Application for Licence Amendment

Licence Number	L9037/2017/1
Licence Holder	Mt Marion Lithium Management Pty Ltd
ACN	666 116 365
File Number	DER2017/000308-1
Premises	Mount Marion Lithium Project Shire of Coolgardie Legal description – Mining tenements M15/1000, M15/717 and on private land known as the Hamptons Lease Areas 52, portion of Lot 105 on Deposited Plan 40396, Volume 2668 Folio 420 Part of Lot 105 on Deposited Plan 40396 Certificate of Title Volume2668 Folio 420 As defined by the Premises maps attached to the Revised Licence
Date of Report	9 September 2025
Decision	Revised licence granted

**Figure 1: Ghost crab pit conceptual plan 1**

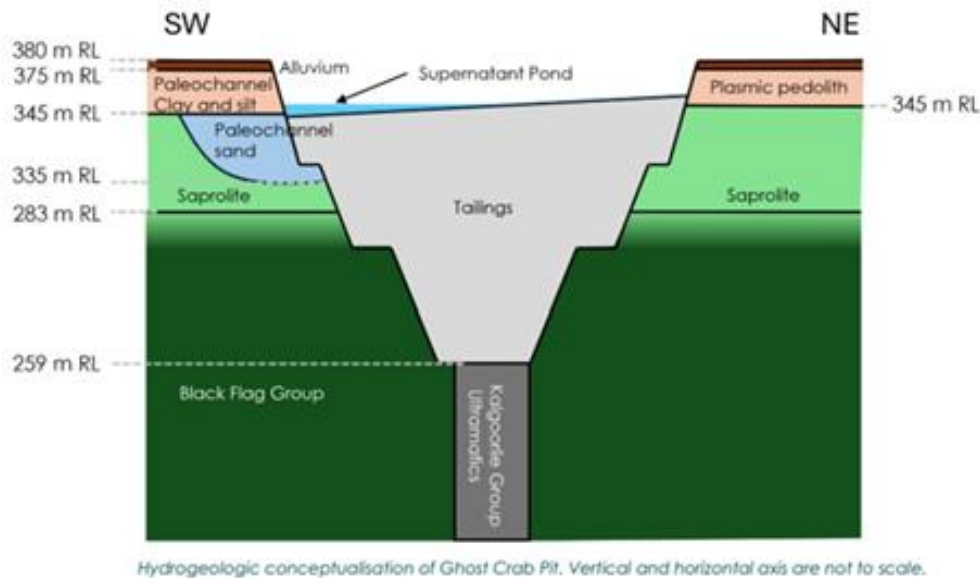
Under the licence amendment, the Licence Holder is requesting to decrease the freeboard of the TSF to 0.5 m from the pit crest (noting a 5.7m variation in pit crest elevation) increasing tailings deposition by 1.5 million cubic metres and increase the TSF lifespan by approximately 2.5 years.

Historic discharge from the TSF is primarily through evaporation and supernatant pond decant recovery, involving minor seepage into adjacent formations. Seepage and mounding data indicates that the Paleochannel (see Figure 1) is considered an aquifer, all other stratigraphic units are considered aquitards. However, the proposed increase to freeboard and resulting head pressure could result in seepage and mounding within the Pedolith and Saprolite formations.
